ORDER UNDER SECTION 96 (2) OF ACT, III OF 1901.

With reference to ^{his}~~their~~ application, dated 23. 2. 1922.Mr. Ramachand Lalabdas per mutasama is informed
Messrs. arethat the plan submitted by ^{him}~~them~~ for building a house on plot No. 91 Survey Sheet K4
situate in Street, Lyari
Road

PLAN SHOWING PROPOSED HOUSE.

ON PLOT NO 91-SHEET K-4.

PLAN OF 1st & 2nd FLOORS

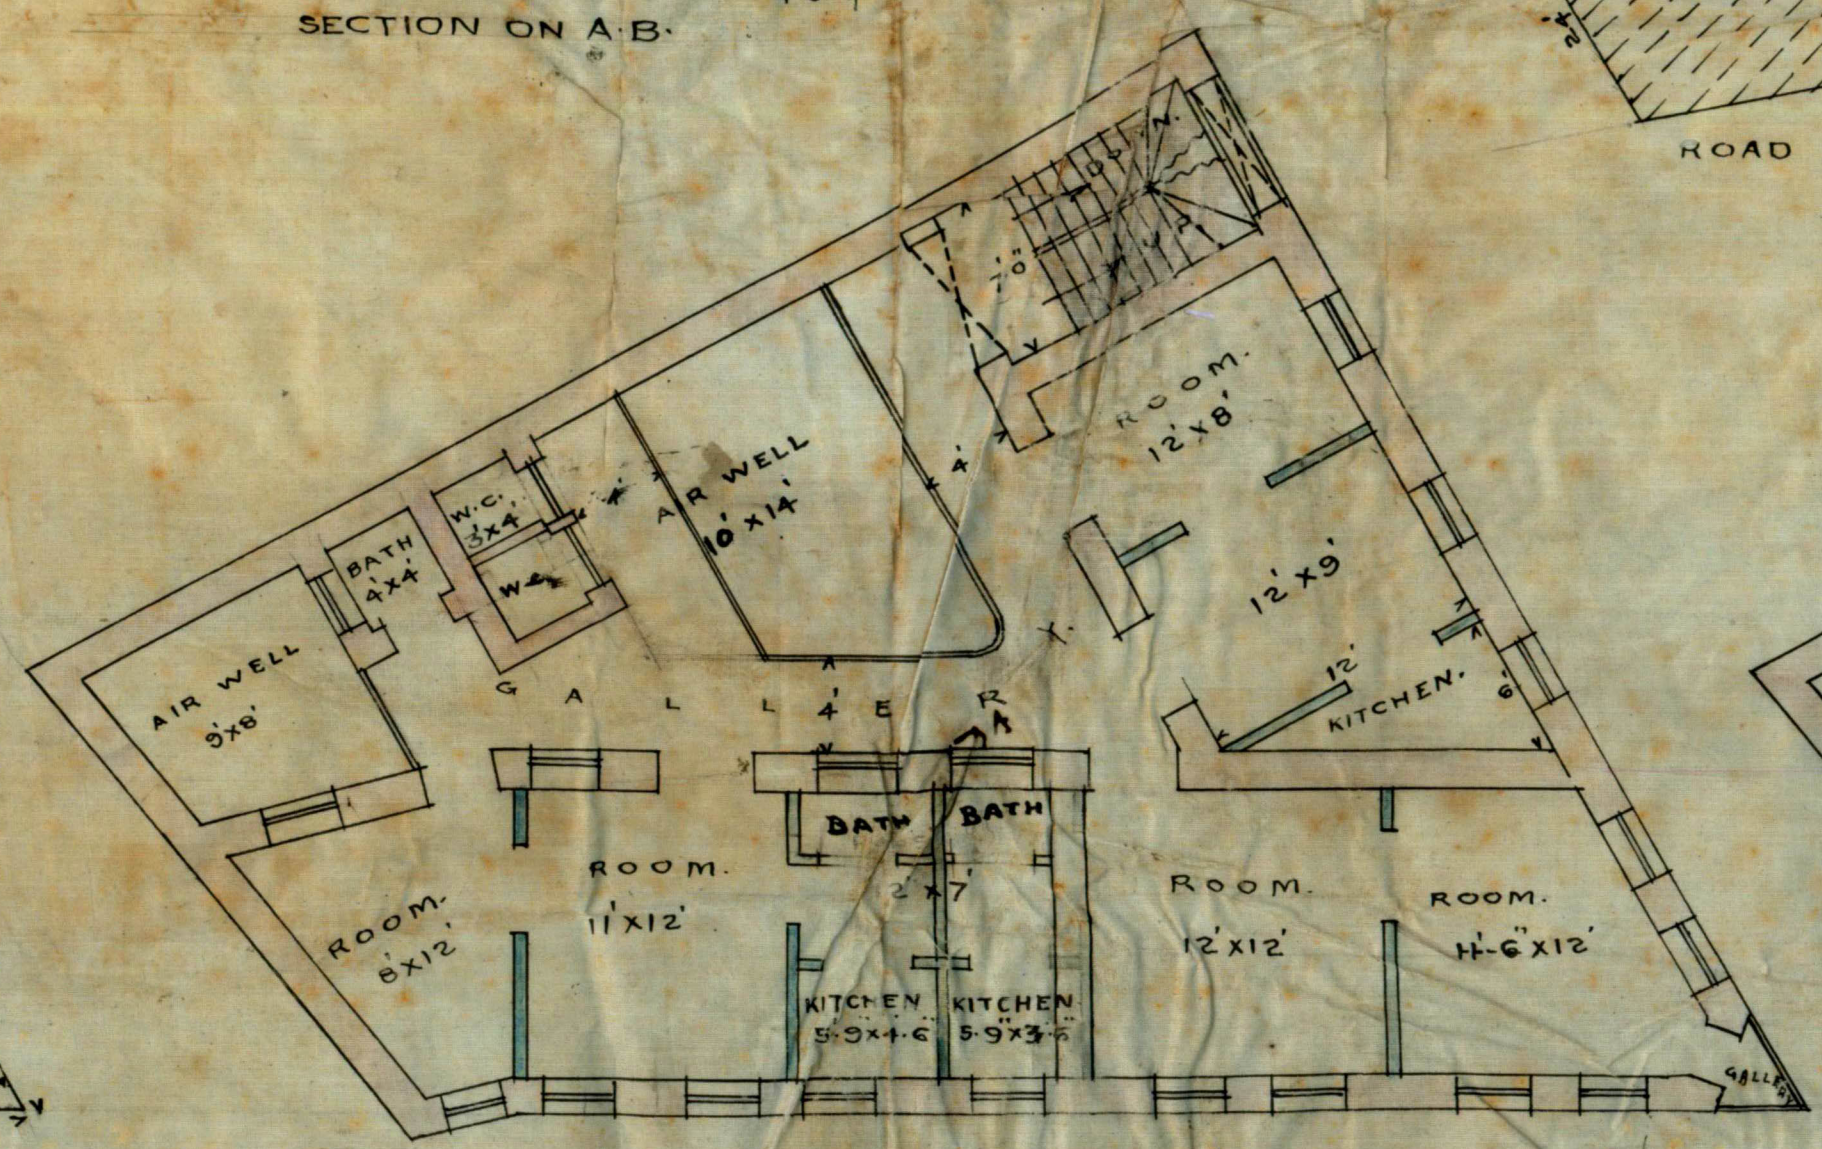
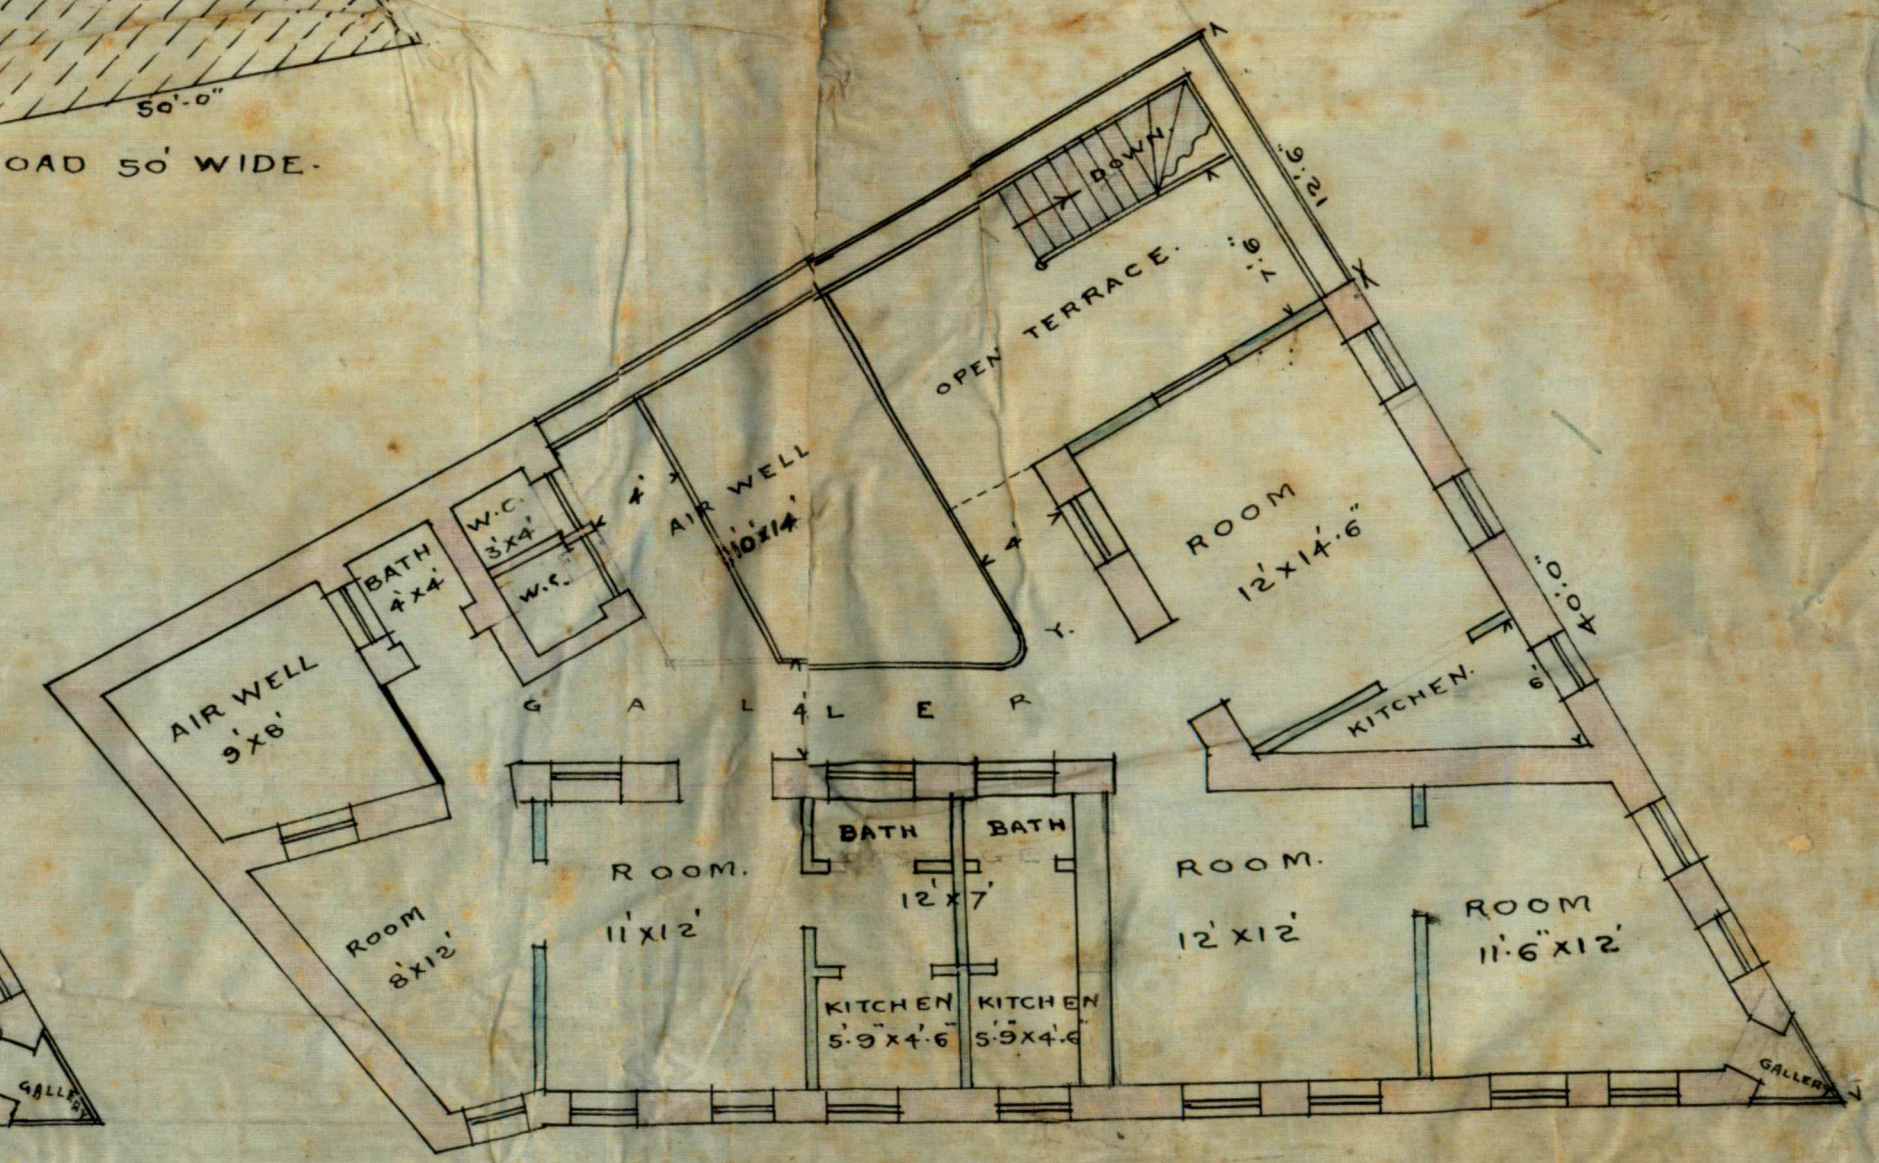
With reference to his application dated 11th February 1922, with a plan for the proposed building on plot No. 91, K-4 Lyari Quarter Mr. Rewachand Walabdas is informed, that the sanitary conveniences are inadequate.

2/ One of the ~~W & S~~ ^{wattle & daub} cross walls of front rooms on the upper floors must be made of stone masonry.

3/ The site plan measurements are incorrect. He is requested to produce his Sanad to check the measurements.

His objection may be complied with
one cross wall must be provided on
the upper floor in the front room, as a tie
to the long wall.

The dimensions of the plot given in the plan
do not tally with the field book - The applicant must
produce his sanad complying with the objections raised by
the A. S.

The owner has provided 2 w.c & 3 baths on each floor which appear sufficient provision in place of 1 w.c & 1 bath.

2/- The wall has been made thicker.

I beg to state that
 the dimensions and the stone
 masonry walls have been
 provided as suggested and
 this request for sanction
 for the same. I further state
 that the more additional work is
 provided - Yours faithfully
